BAR Meeting  
July 7, 2010

**ISSUE:** Permit to Demolish/Encapsulate and Addition/Alterations  
**APPLICANT:** Bruce & Donna Henry by Dimond Adams Design Architecture  
**LOCATION:** 803 Cameron Street  
**ZONE:** CD / Commercial

**BAR CASE #2010-0155 & 0156 7/7/2010**

Figure 3. Plat showing proposed addition.

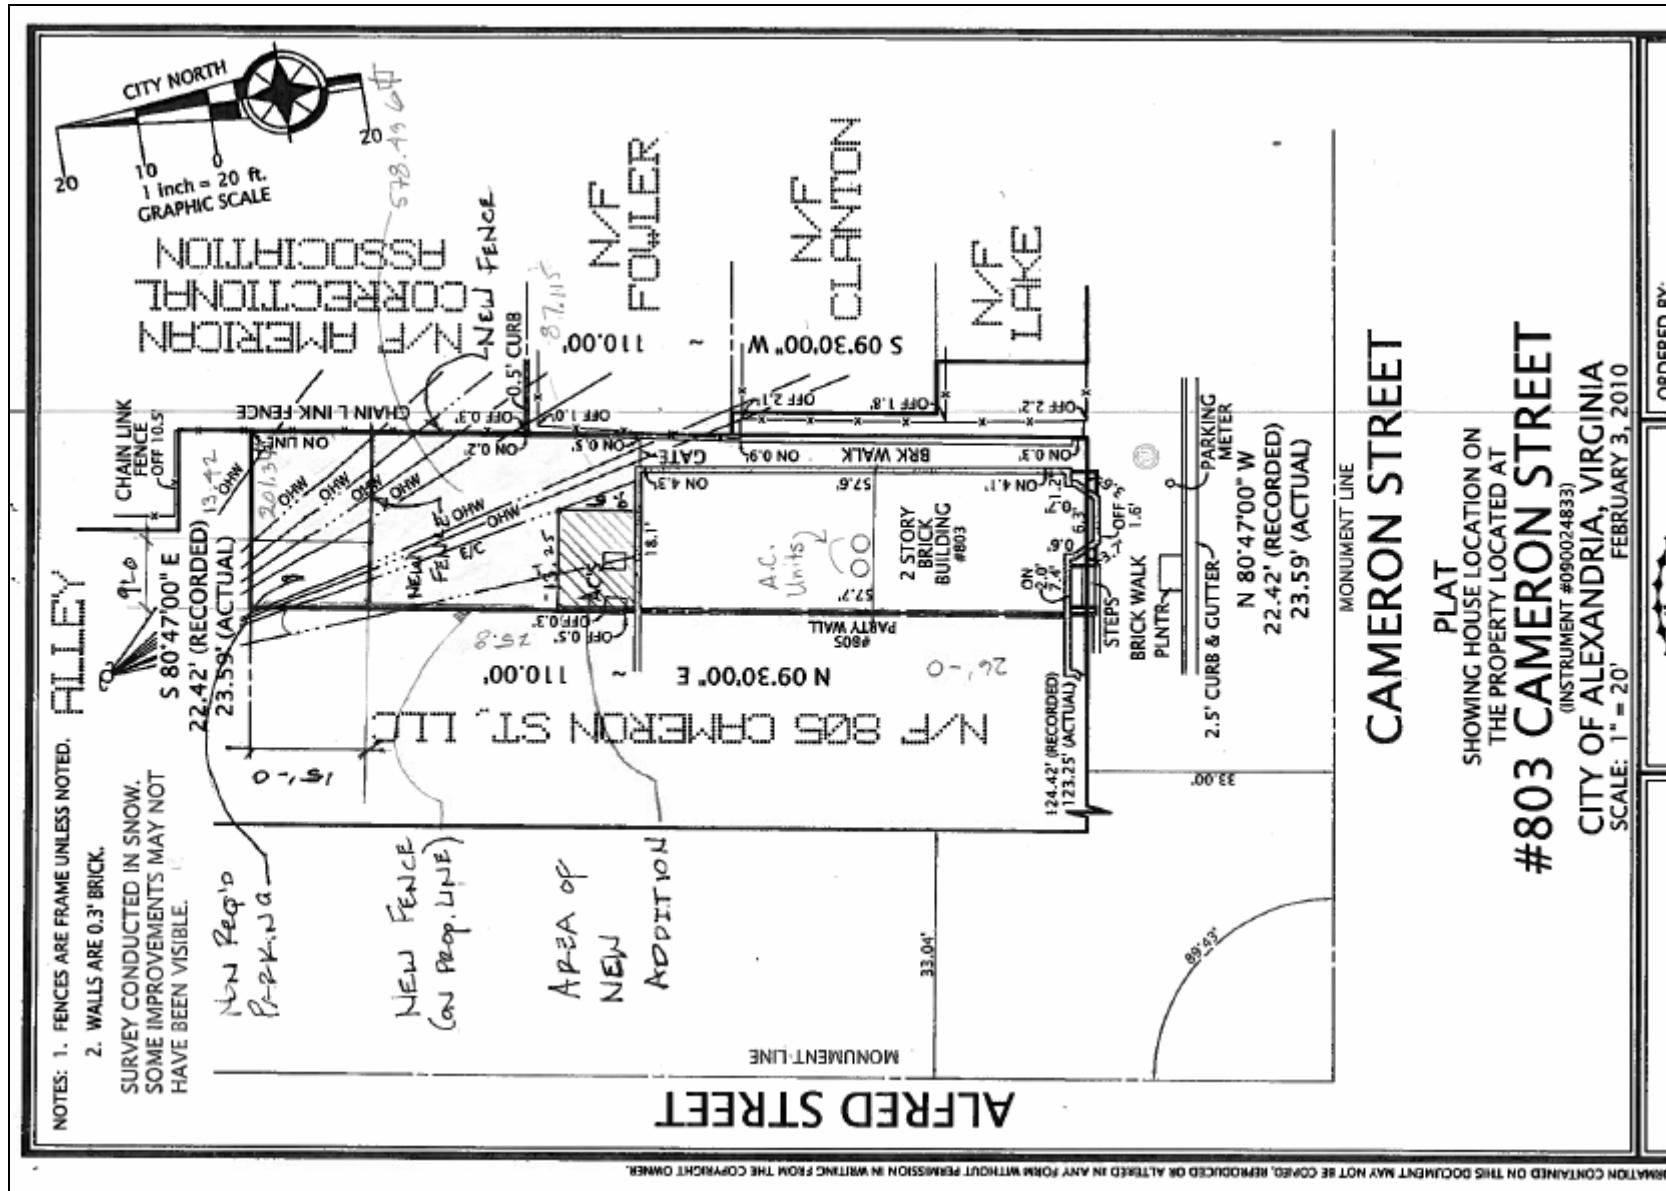
The construction of an addition to any building within a historic district must be evaluated not only for its impact on the building to which it is being attached, but also for its impact on the district as a whole. The *Design Guidelines* encourage “designs that are respectful of the existing structure and which seek to be background statements or which echo the design elements of the existing structure.” As the attached drawings illustrate, the proposed addition does not overwhelm the existing building yet will clearly read as an addition. This modest addition is appropriate in respect to massing, scale and form. The use of a classical post and lintel

vocabulary is common for porches and the proposal recalls the typical evolution of late 19<sup>th</sup> century sleeping porches as they were enclosed over time. However, Staff believes that a taller and more complete, but vernacular, entablature (architrave, frieze and cornice) on the second floor would improve the neoclassical proportions. Staff will continue to work with the applicant to refine the architectural details at the intersection where the new porch roof meets the existing shed roof of the ell and to insure that it can be properly drained.

1. That the applicant work with Staff to visually strengthen the second floor entablature on the proposed rear addition.
2. That the proposed fence be painted or stained.

Figure 8. Sight lines showing rooftop HVAC units.

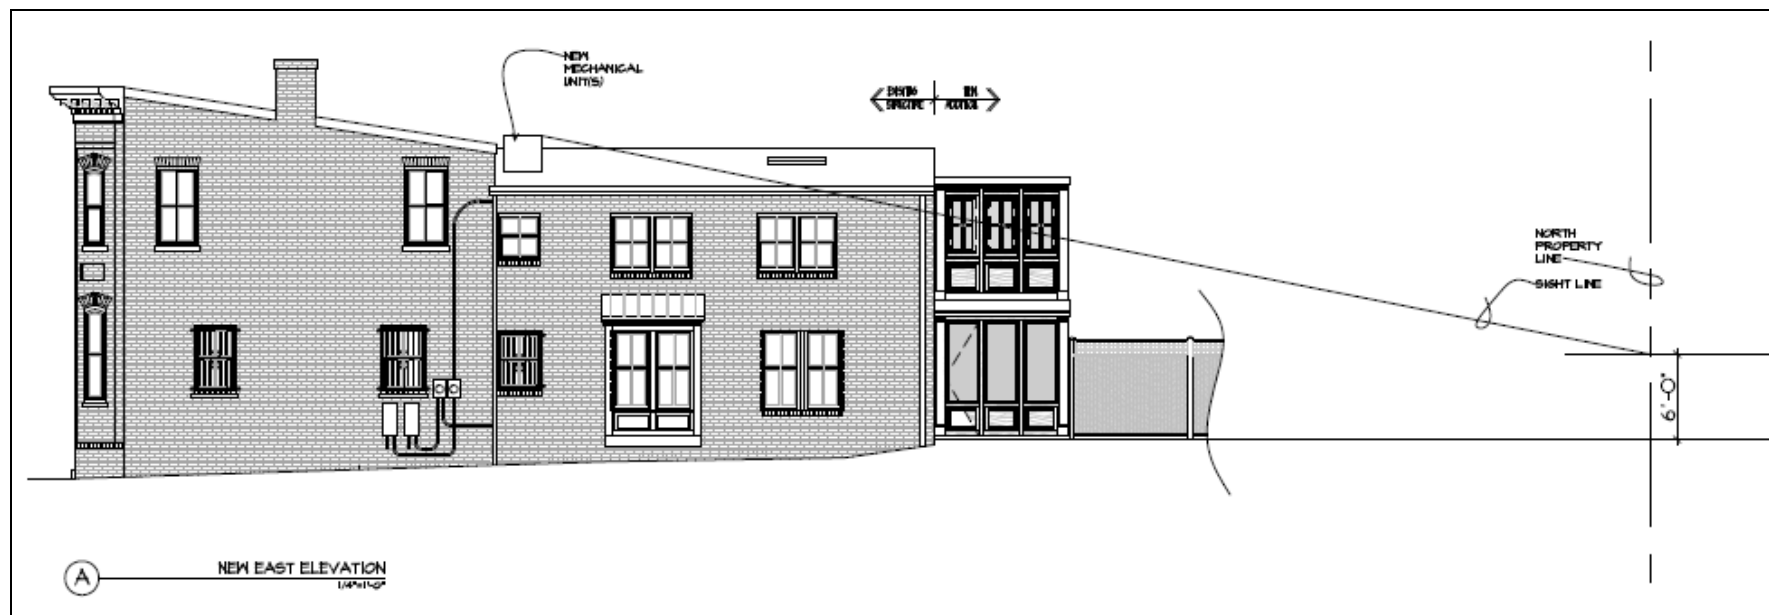
Staff has no objection to the proposed skylight or the placement of HVAC units on the roof of the existing rear addition. The applicant has provided sight lines indicating that the rooftop HVAC units will not be visible from the public right-of-way and therefore will not require a waiver of the screening requirement.
